Access Compliance Report

Public Rights-of-Way

(Curb Ramps)

Intersection ID: 18436	Main Street: E_INDEPENDENCE_BV	Cross Street: SHARON_FOREST_DR	Location: NE
ADA ID: DE39475D4269	Ramp Type: PerpDiag	Initial Pass/Fail: Fail	Overall Compliance: No
Severity Score: 22.5			
Codes/Mitigation Info/Possible Solution		Field Measurements/Component Compliance

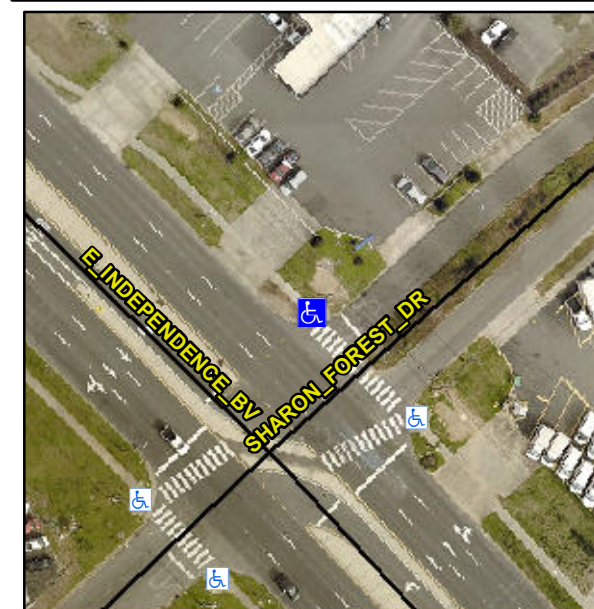
Not Found, R304.5.1, R304.2.2, R304.5.3

Compliance	Description	Data	Compliance	Description	Data
N/A	Ramp Length (in)	66.0	No	Ramp Slope (%)	11.8
No	Ramp Width (in)	45.0	No	Ramp XSlope (%)	2.7
N/A	Flare Type LT	N/A	N/A	Flare Type RT	N/A
N/A	Flare Slope LT (%)	N/A	N/A	Flare Slope RT (%)	N/A
N/A	Flare Traversable LT?	N/A	N/A	Flare Traversable RT?	N/A
N/A	Landing Length (in)	N/A	N/A	DWS Provided?	N/A
N/A	Landing Width (in)	N/A	N/A	DWS Contrast?	N/A
N/A	Landing Slope (%)	N/A	N/A	DWS Length (in)	N/A
N/A	Landing X Slope (%)	N/A	N/A	DWS Full Width?	N/A
N/A	Landing Curb? (Y/N)	N/A	N/A	DWS Offset (in)	N/A
N/A	Shared Landing?	N/A			
N/A	Gutter Ponding?	N/A	N/A	Gutter Slope (%)	N/A
N/A	Gutter Lip Ht (in)	N/A	N/A	Gutter X Slope (%)	N/A
N/A	Painted X Walk1?	No	N/A	Painted X Walk2?	Yes
	X Walk 1 Direction	To SW		X Walk 2 Direction	To SE
N/A	X Walk 1 Width (in)	N/A	N/A	X Walk 2 Width (in)	120.0
	X Walk 1 Slope (%)	4.1		X Walk 2 Slope (%)	1.4
	X Walk 1 X Slope (%)	0.4		X Walk 2 X Slope (%)	3.1

Remove & Replace Curb Ramp With Two New Directional Ramps or Equivalent.
